802.3dj D1.0

Comment Resolution - Electrical track

Adee Ran, Cisco

Figure 176E-2—Components of a 200 Gb/s per lane AUI-C2M interface and insertion loss budget at 53.125 GHz

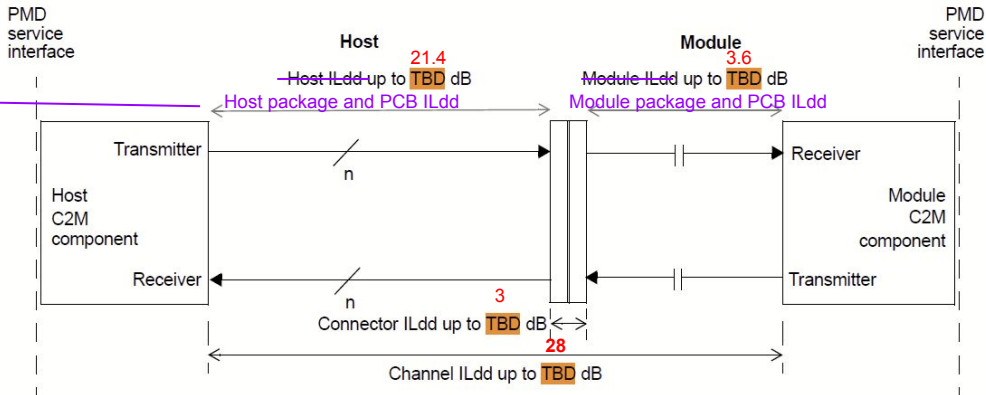
Figure depicts loss should be bump-bump

The IL_dd for AUI C2M channel is a TBD

The referenced presentation is https://www.ieee802.org/3/dj/public/24_01/lusted_3dj_03_2401.pdf. The comment is against 176E.4.1 (Recommended channel characteristics/Insertion loss), which has an equation for the ILdd limit. The suggested remedy does not address the equation. The proposed value for this TBD (Channel ILdd) is **33 dB**. Comment #134 suggests **28 dB** for the same TBD.
